Department of Energy
Washington, D.C. 20545

Docket No. 50-537
HQ:S:82:159

ADDITIONAL INFORMATION REGARDING EMERGENCY PLANNING, PRELIMINARY SAFETY
ANALYSIS REPORT (PSAR) SECTION 13.3

Enclosed are the responses to requests for additional information regarding emergency planning of the Clinch River Breeder Reactor Plant. Enclosure 1 contains information on the location of plant emergency personnel and plant data transmissions. This information should be considered preliminary, as discussed with Mr. Williams of the Emergency Preparedness Licensing Branch, and will be updated for the Final Safety Analysis Report. Enclosure 2 contains information on the control room locations in Figure 13.3-2, a description of the Technical Support Center (TSC), habitability features of the TSC, and the plant data acquisition system. This information will be incorporated into Amendment 75 to the PSAR scheduled for submittal in January 1983.

Figure 1

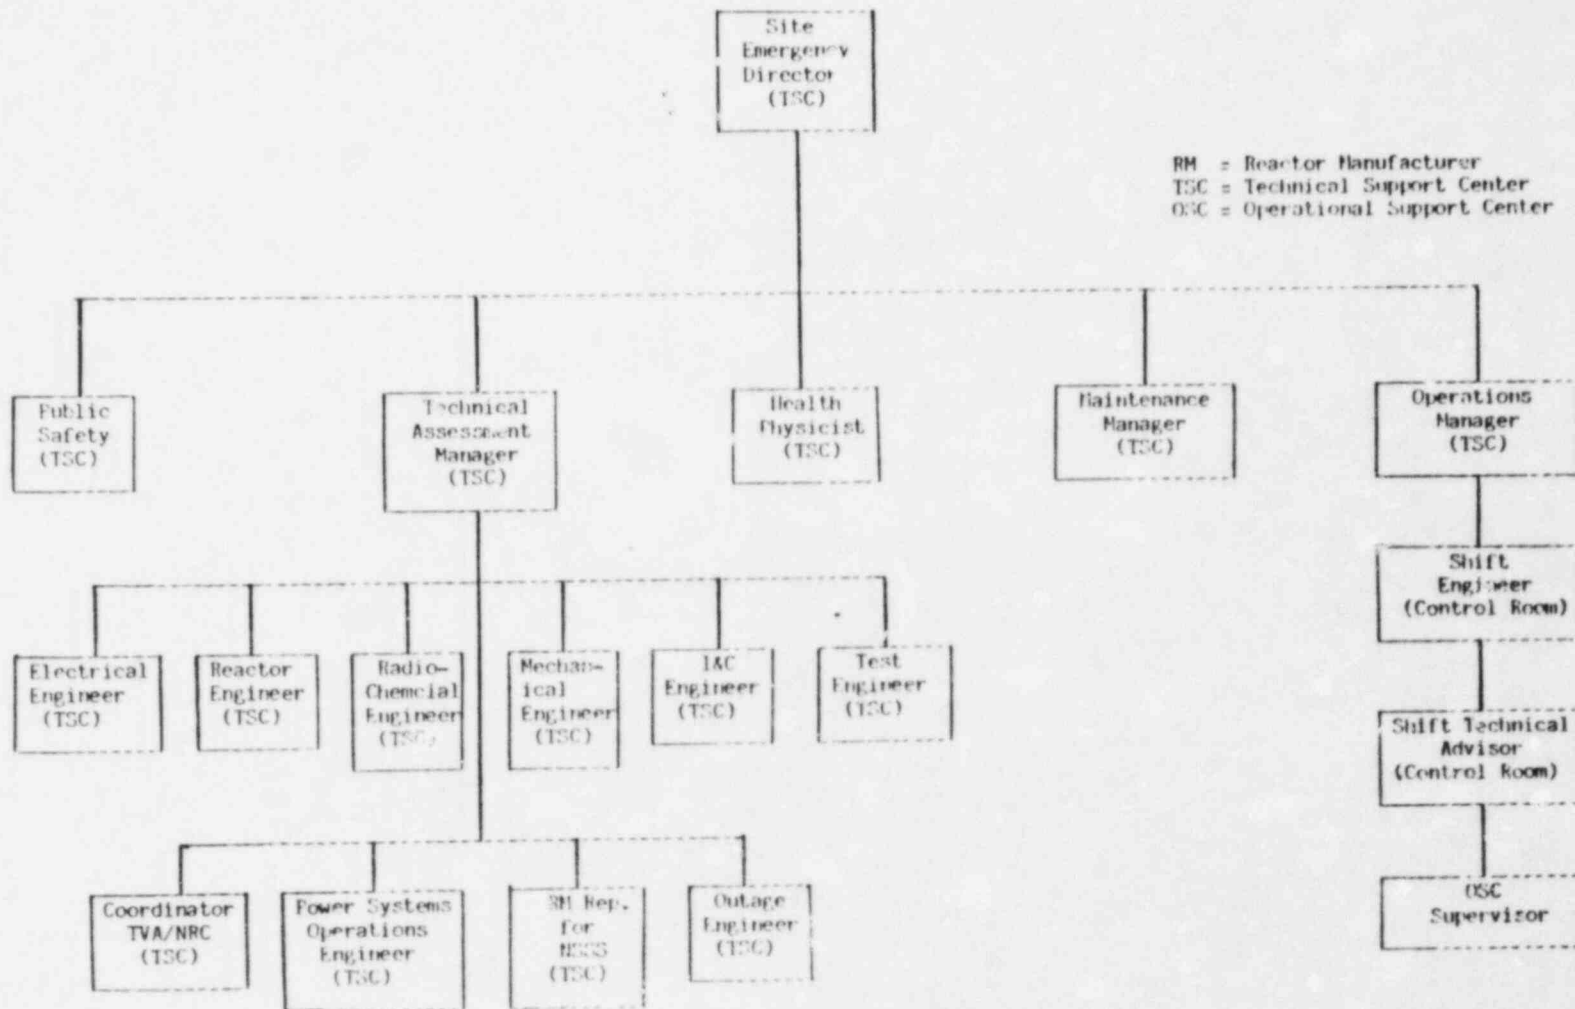
Provide a matrix showing the location of key plant emergency personnel during: (1) a site alert, (2) a site area emergency, (3) a general emergency.

TVA staffs the plant TSC and OSC from alert to all higher emergency classifications. Therefore, the attached matrix will be the same for all three emergency classifications.

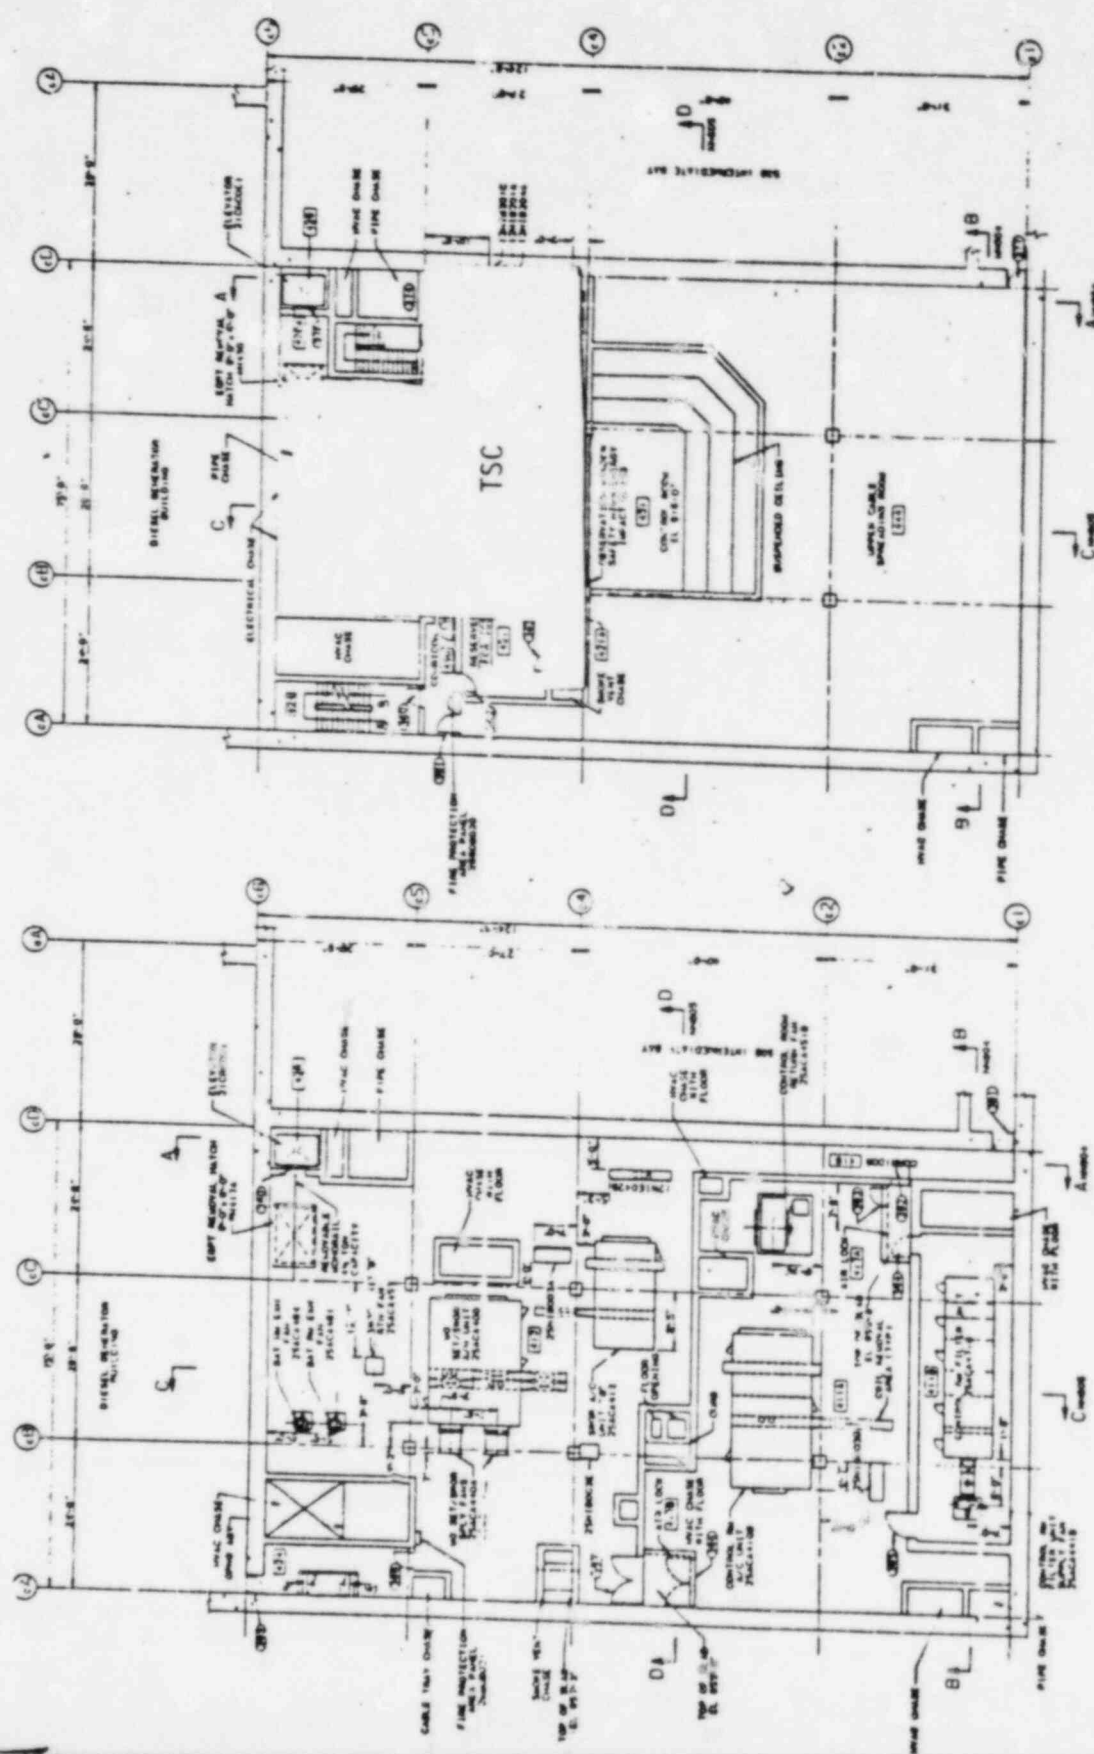
Insert

on the B31 level of the control building (see Figures 1.2-82 and 1.2-86)

An on-site Operational Support Center (OSC) will provide a location where support personnel can assemble and where support can be coordinated and will provide communication with the control room and the TSC. The location of the OSC will be ~~an existing area of the plant~~. The OSC will have access to equipment necessary to support the plant emergency response *in the lunch room area of the plant services building (see PSAR figure 13.3 and 1.2-11)*
